New Age Garments Ltd New Age Apparels Ltd Kei Lock Garments Ltd

Nishchintopur, Asulia, Savar, Dhaka
(23.924895, 90.308234)
9th April 2014

Executive Summary (continued)

Construction Health and Safety (Construction and Factory Workers)

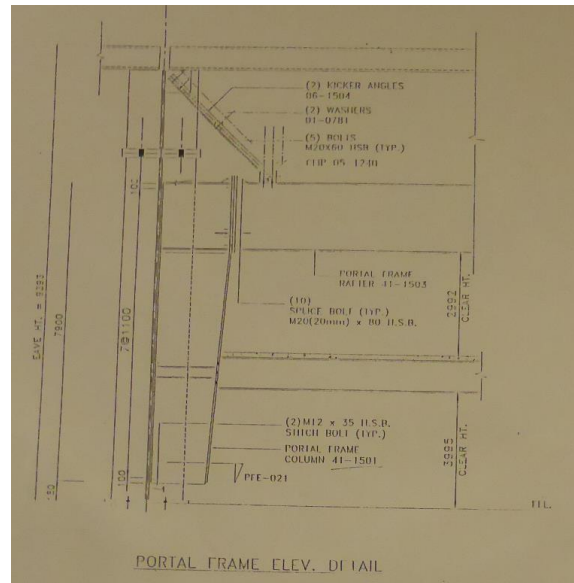
- No edge protection for workers building levels above. Risk of workers or objects falling to levels below.
- Risk to workers accessing lower levels from falling objects from above (partial protection in place as shown).

- Review edge protection to prevent workers falling / items falling on factory workers.

- Factory Management to consider edge protection measures during on-going construction works.
- Ensure all access/ egress routes from factory are protected from falling items from above.

Corrosion of structural steelwork (Building 2)

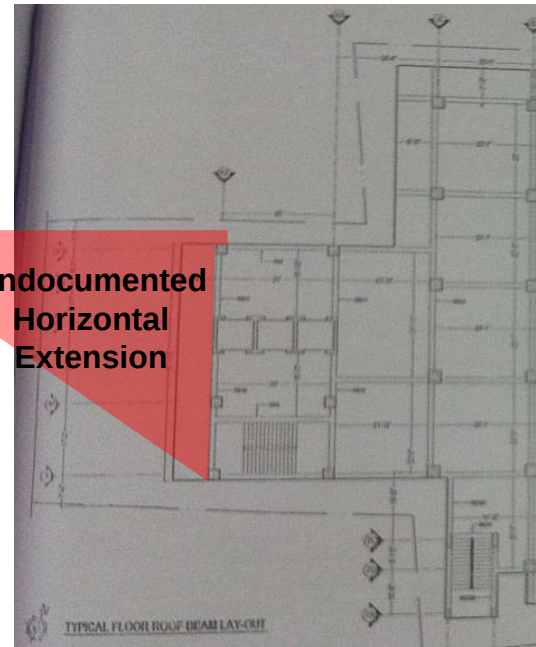
- Corrosion of steelwork and deterioration of the corrosion protection noted in a number of locations in Building 2.
- Corrosion most evident in toilet areas where steel is exposed.

Example of mezzanine support beam (as viewed from top of secondary shallow ceiling slab above Building 2 toilets) and metal deck showing signs of significant corrosion due to leaking at drainage drop.

- Engineer to assess extent of corrosion of steelwork in Building 2.
- Where section capacity has been compromised, structural capacity of the corroded section should be assessed.
- Causes of corrosion to be determined and repaired (e.g. leaks around toilet drainage points).

- Corroded steelwork to be thoroughly cleaned and remediated as required following engineering assessment.
- Corrosion protection to be repaired.

Undocumented structure to the south-west of Building 3

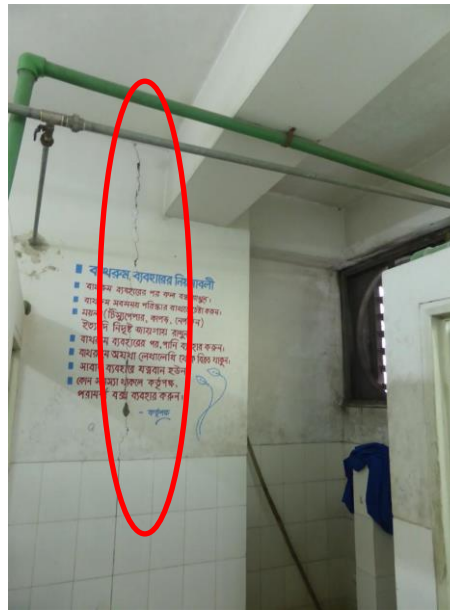
- No structural or permit drawings available.
- Some irregular structural arrangements, including 5.8m cantilever beam.
- Evidence of distress of façade due to deflection of cantilevers.

- Undertake a Detail Engineering Assessment of the undocumented portion of Building 3 (see above) as per the scope outlined on the following page.
- Particular attention to be paid to the long-span cantilever on the front façade and slab cantilevers supporting facades which are demonstrating significant distress.

- Undertake any strengthening or modification of the undocumented extension arising from the Detail Engineering Assessment.

Undocumented
Horizontal
Extension

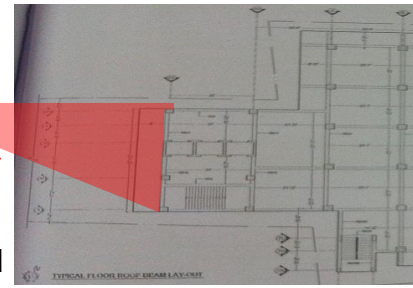
Lack of relevant structural design or documentation (Building 3)

- Ensure no change of use or increase of applied loading to front office structure
